Site visit - 10/28/19
2896 Hunt Valley Drive
Glenwood, MD

APPLICATION FOR VARIANCE
TO COMAR ONSITE WATER/SEWER FOR MDE APPROVAL

2896 Hunt Vallet Drive Glenwood, MD 21738

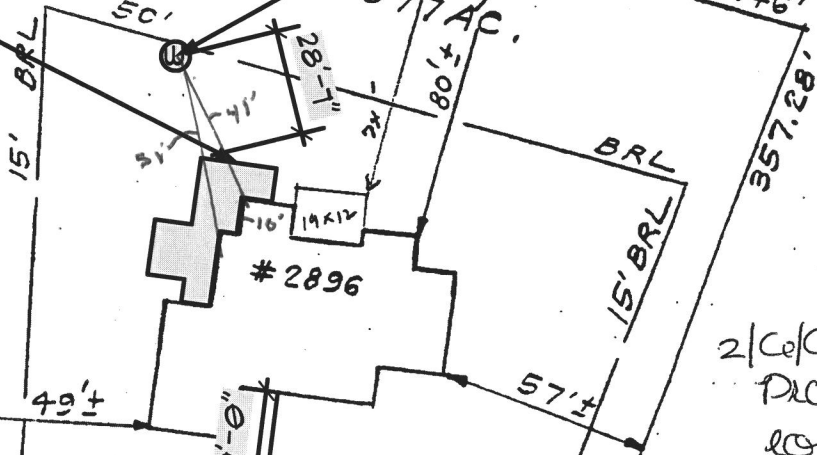
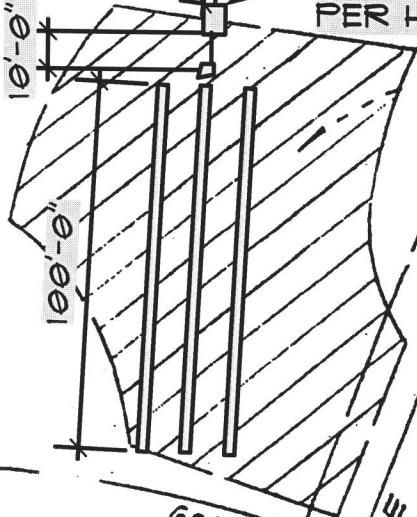
Homeowners would like to build an addition on the house that would be 28'7" from existing well. The addition will have a crawlspace

Hi Steve. Attached is a variance request to allow a house addition to encroach on the 30' well setback to 28'. I don't recall if we've gotten anything from you on any kind of reduced distance in which a variance would be automatically approved? Thanks

Approved. I'll sign and send later.

PS John B was not successful in being able to get his memo out which basically said he was ok with your office approving down to 15 feet, but regardless use that as a general guide. So, from less than 30 feet down to 15 ft is probably an automatic approval.
